## SB, Muffler, K970, 2024-05

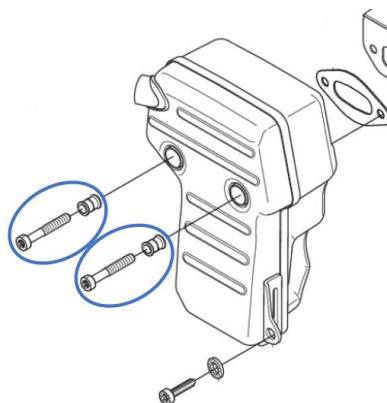
Field reports have shown that the muffler can come lose on products in the K970 family. As an improvement, longer screws and a sleeve have been introduced for the two top screws. These are the same screws and sleeves that are used to hold down the cylinder on K970.

This solution is backwards compatible. The screws and sleeves can be installed on existing products.

Article Name	Old Article Number	New Article Number
Screw	Already existing article	544218440
Sleeve	Already existing article	578119101
